NEWS LETTER

Model: CK-6G7GDI	Date: Jan. 18, 2002		Nº: 02 - 008			
	Distribution No. by market					
Group: FUEL (13)	G. EXP	EUR	MMAL	CHRY.	MMSA	US TERR.
	-----	02	-----	-----	-----	-----

Subject: **Repair procedure for poor acceleration, lack of power and low peak out**

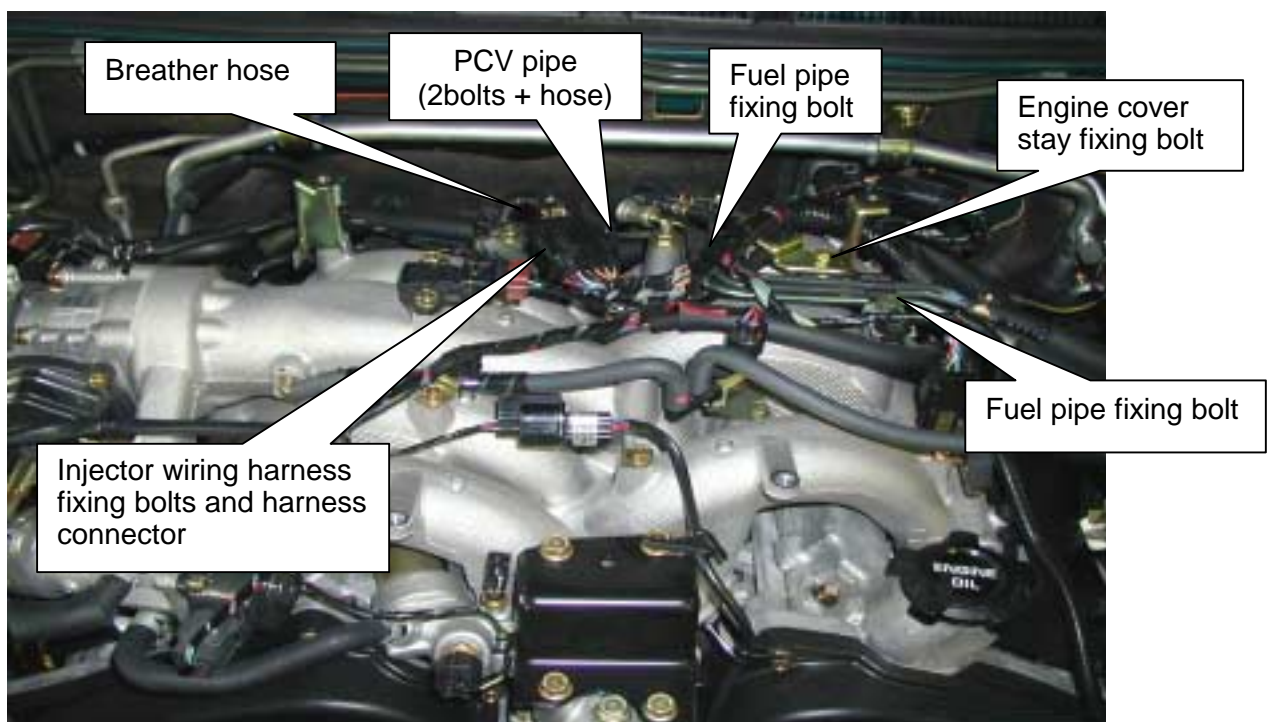
It is due to insufficient fuel flow caused by blocked filter in a high-pressure fuel pump. This filter is blocked by many foreign particles passing through a gap at a low-pressure fuel pump module second filter poor adhesion part.

Improving sealing performance of a low-pressure fuel pump module second filter by changing adhesion method between a filter paper and its plastic end plate from epoxy adhesive type into ultra sonic welding type.

And a material of a low-pressure fuel pump motor commutator has been changed from copper to carbon to avoid fuel oxidization caused by copper wearing powder acting as a catalyst.

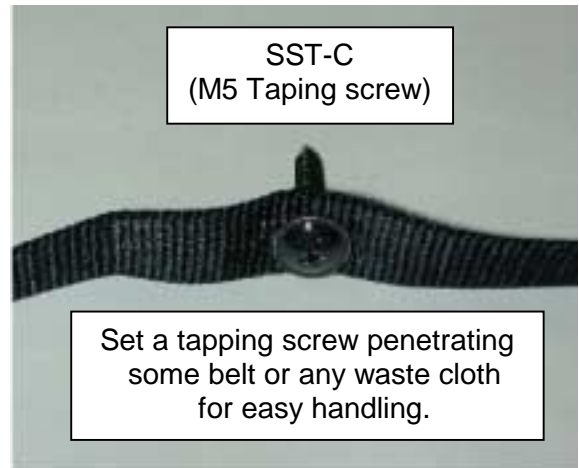
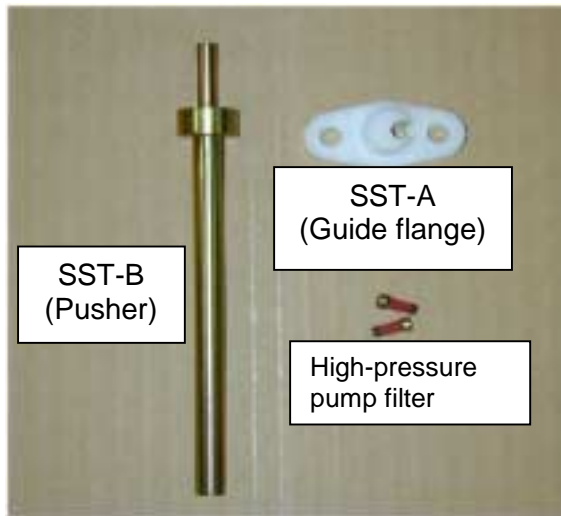
4. Remove the engine cover and all the parts shown in the following picture.

5. Remove 2 fixing bolts of the fuel pressure hose connection flange.
Cope with seeping fuel and clean up the fixing base.

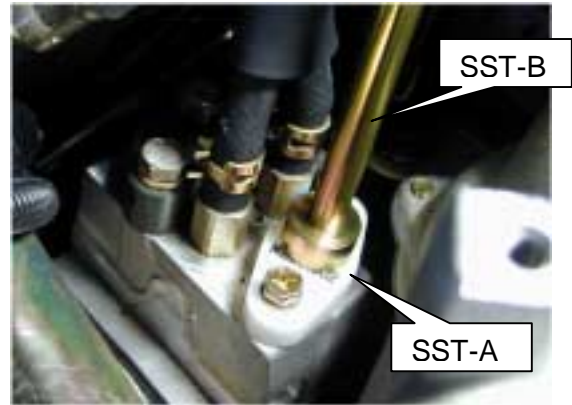
6. Set the SST-A on the fixing block for the fuel pressure hose as shown in the following picture.

7. Screw the SST-C in the guide hole **completely to the end**, and pull out the existing filter **at one go-off**.

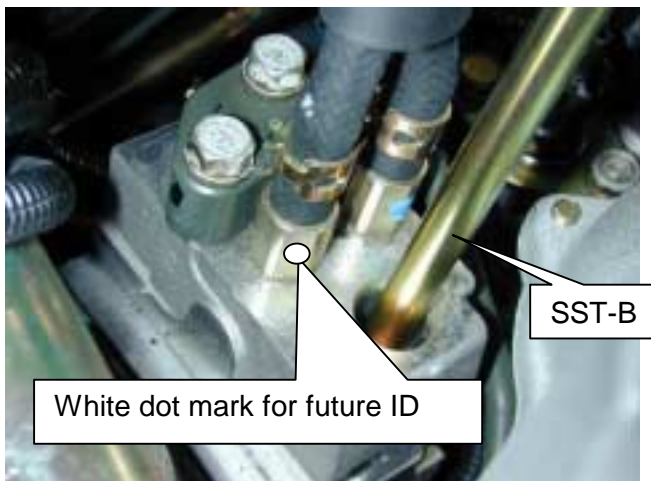
8. Insert a new filter (MD619962) in the guide hole of the SST-A, and gently hammer it in with the small end of SST-B to the end.
